EASTERN REGIONAL POWER COMMITTEE

Minutes of Special Protection Coordination for “To review the data submitted by BSPTCL & JUSNL and also to discuss the road map for the site visit” held at ERPC on 29-03-2016

SINGLE LINE DIAGRAM OF 220/132 KV GRID SUB-STATION ADITYAPUR-II, RAMCHANDRAPUR

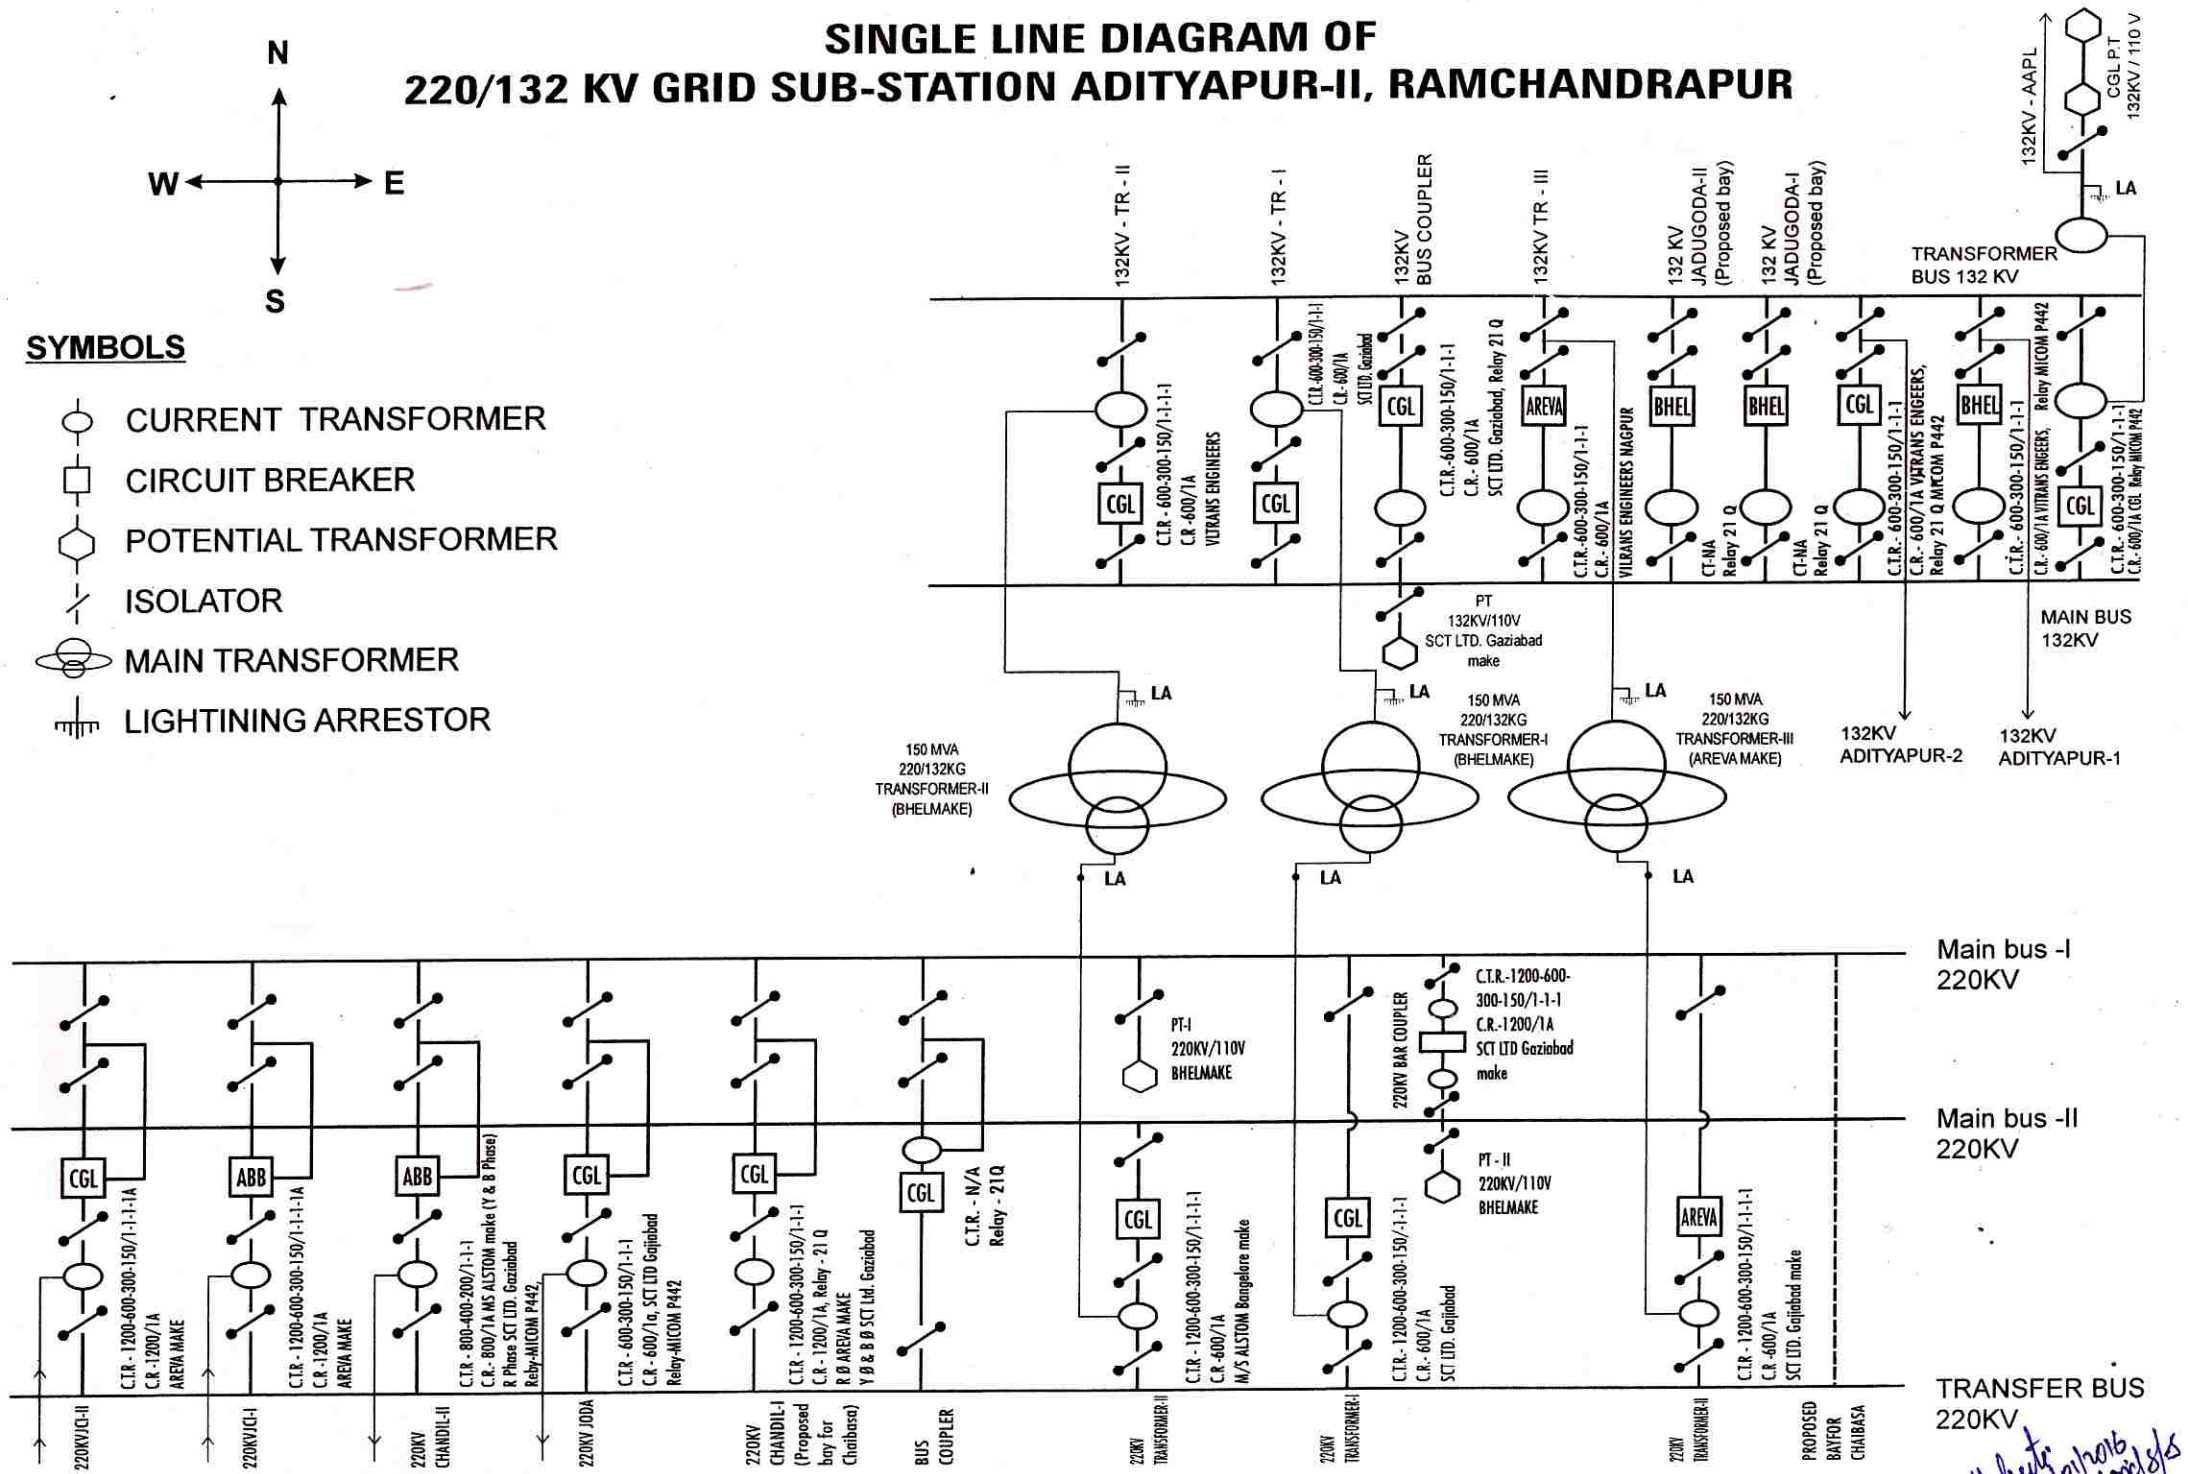
2) Ramchandrapur S/stn: (clear SLD is required)

- i. The CT rating of 132kV side of 150 MVA transformer is set at 600/ 1 which seems on the lower side. It requires further analysis and review
- ii. There are only one (1) trip coil in the breakers as seen from the results in 220kV breakers.
- iii. Provision of two separate DC as Main DC#1 and Main DC#2 for individual bays are to be studied for redundancy.
- iv. Breaker trip time of ICT 220kV Breaker: Y pole- 589 ms, B Pole-589 ms which is very high.
- v. Here also the bay CTs which are more than 25 years requires the characteristics of the CT to be analysed.
- vi. DP setting not as per ERPC philosophy.
- vii. Differential relay not numerical.
- viii. Earth resistance high: 2Ω
- ix. DC positive earthed.

*JUSNL submitted the SLD of Ramchandrapur GSS which is enclosed at **Annexure-A1** and updated the following:*

- *220 kV Breaker of Ramchandrapur G/S/S will be checked for operation timing of trip coil-1 trip coil-2 by suitable agency.*
- *Purchase order for second set of sub-station batteries set with charger has already been placed and it will be commissioned after delivery.*
- *Breaker trip time of ICT 220 kV breaker will be rechecked and corrective measures to be taken if required.*
- *There are some C.Ts which are 25 years old their tan delta characteristics and other specifications like knee voltage and ratio errors will be checked very soon with the help of suitable agency.*
- *There are two trip-coil in the breakers but during testing the agency missed to test the second coil as they could not trace the contact of second coil. The same will be traced and tested.*

- ✓ *Carry out Tan-delta measurement of all CTs and replace the CTs which are violating Tan-delta characteristics.*
- ✓ *Identify and connect the proper protection core of PT for protection purpose.*
- ✓ *All old PTs may be replaced with proper ratings, core and class.*
- ✓ *Old EM relays are to be replaced with Numerical relay for ICT-I&II.*
- ✓ *Circuit Breakers are to be tested with both the trip-coils and results to be submitted.*
- ✓ *Circuit Breaker of ICT-I may be checked as the CB trip time is very high (589 ms).*
- ✓ *Take suitable measure for detection and rectification of the DC earth fault.*
- ✓ *While commissioning of second set of Battery Bank, proper measures to be taken for proper connection & segregation of DC#1 & DC#2 for redundancy & segregation as per the standard practices followed.*
